DART AEROSPACE LTD	Work Order:	101173
Description: Crosstube Assembly (205/212 High Aft)	Part Number:	D212-664-241
Inspection Dwg: D212-664-241 Rev: D		Page 1 of 2

DRAWING NO. D212-664-241	TITLE CROSSTUBE ASSY (205/212 HI AFT)	REV. D	DART AEROSPACE LTD ENGINEERING ORDER		D.E.O. NO. D212-664-241-D-1	SHEET NO. SHEET 1 OF 2	SCALE NTS
DRAWN	CHECKED	MFG. APPR.	APPROVED	DE APPR.			
DATE 11.04.07	DATE 11.04.11	DATE 11.04.12	DATE 11/04/12	DATE 11.04.12

DRAWING NO. D212-664-241	TITLE CROSSTUBE ASSY (205/212 HI AFT)	REV. D	DART AEROSPACE LTD ENGINEERING ORDER		D.E.O. NO. D212-664-241-D-2	SHEET NO. SHEET 1 OF 1	SCALE NTS
DRAWN P	CHECKED ASS	MFG. APPR. DS	APPROVED MP		DE APPR. H		
DATE 11.07.15	DATE 11.07.20	DATE 11.07.21	DATE 11/27/21		DATE 11.07.21

**D212-664-241/-241B
ASSEMBLY DETAIL**

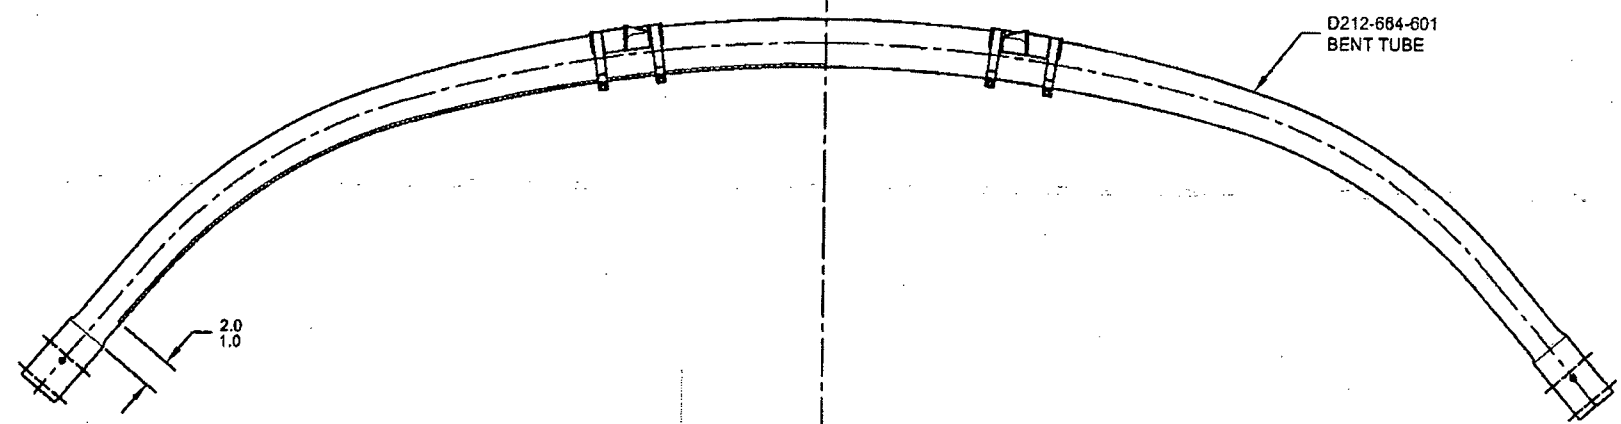
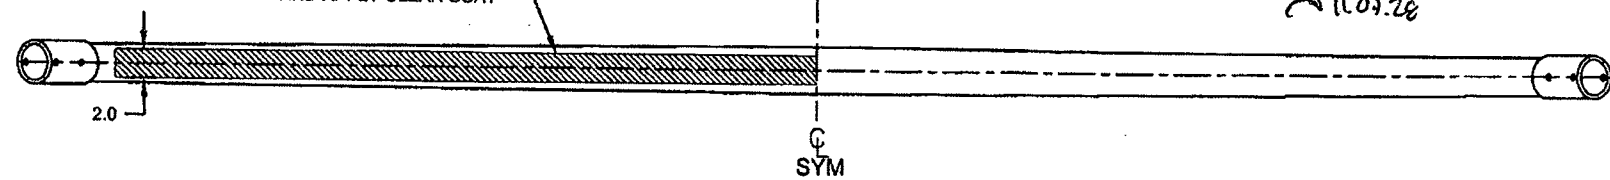
PURPOSE:

ADD AN INSPECTION WINDOW TO UNDERSIDE OF CROSSTUBE.

NOTES 2 OF SHEET 1 IS AMENDED AS FOLLOWS:

- 2) FINISH: CHEMICAL CONVERSION COAT PER DART QSI 005 4.1
PRIME INSIDE AND OUTSIDE PER DART QSI 005 4.2
MASK UNDERSIDE OF CROSSTUBE AS SHOWN (HATCHED AREA) AND
PAINT OUTSIDE PER DART QSI 005 4.2
REMOVE MASKING AND APPLY CLEAR COAT

MASK AREA PRIOR TO PAINTING,
REMOVE MASKING AFTER PAINT
AND APPLY CLEAR COAT
